HISTORIC AND DESIGN REVIEW COMMISSION

HDRC CASE NO: 2015-339

ADDRESS: 714 E EVERGREEN

APPLICANT: Richard Edgerton
OWNER: Richard Edgerton
TYPE OF WORK: Exterior modifications

EXISTING FRONT ELEVATION

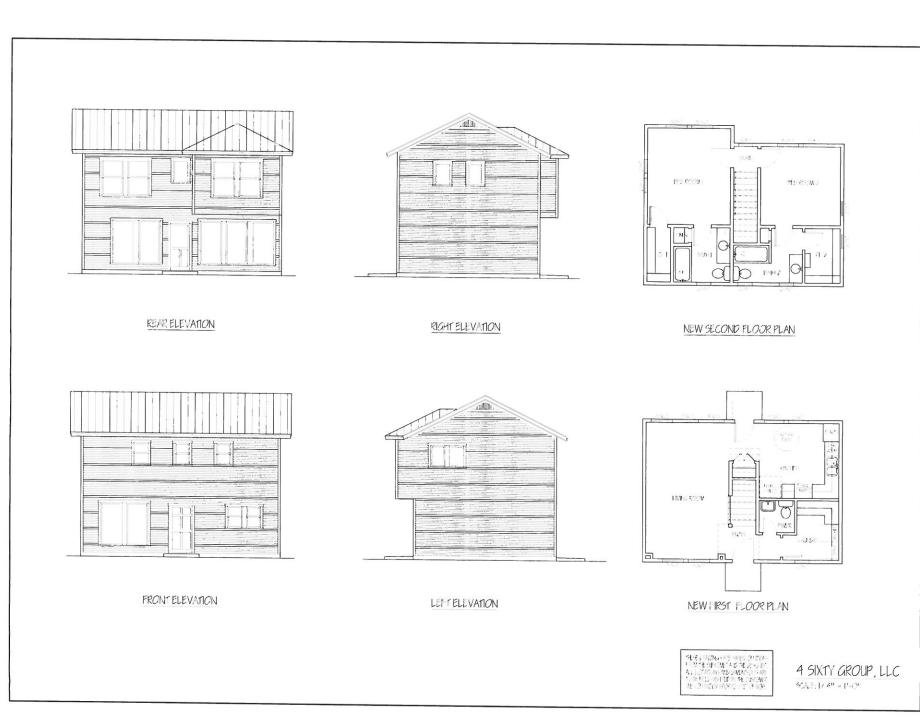
- d. The carriage house currently features a lower level that features two existing carriage doors and an entrance door on the front (north) elevation, a blank left (east) elevation, one window on the rear (south) elevation and no windows or doors, but a staircase on the right (west) elevation.

- e. The upper level currently features three windows on the north elevation, two, double windows on the south elevation, two windows and a door with stair access on the west elevation and a double window on the east elevation. The applicant has provided a written narrative stating that no upper level windows will be altered, however has provided conflicting elevations.

- f. Regarding the lower level, on the north elevation, the applicant has proposed to remove both original carriage doors, relocate the entrance door to the center of the structure and add two groupings of window openings, both of which feature contemporary dimensions. According to the Guidelines for Exterior Maintenance and Alterations 2.A.i., existing window and door openings should be preserved. In addition to the previously mentioned Guideline, per 2.B.iv., new windows should match the historic or existing windows in terms of size, type, configuration, material, form, appearance and detail. The applicant's proposal is not consistent with the Guidelines. Staff recommends that the applicant retain the existing carriage doors.

- g. Architectural elements that provide a definitive answer for the previous use of a structure should always be maintained and preserved. Staff finds that the retention of the existing, original wood carriage doors would lead to the preservation of a character defining feature that readily identifies this structure as once being a garage or carriage house

Staff does not recommend conceptual of the removal of the existing original carriage doors or the elimination of original window and door openings based on findings e through g. Staff recommends that the applicant retain the original carriage doors as well as provide elevations that are consistent with the project narrative.
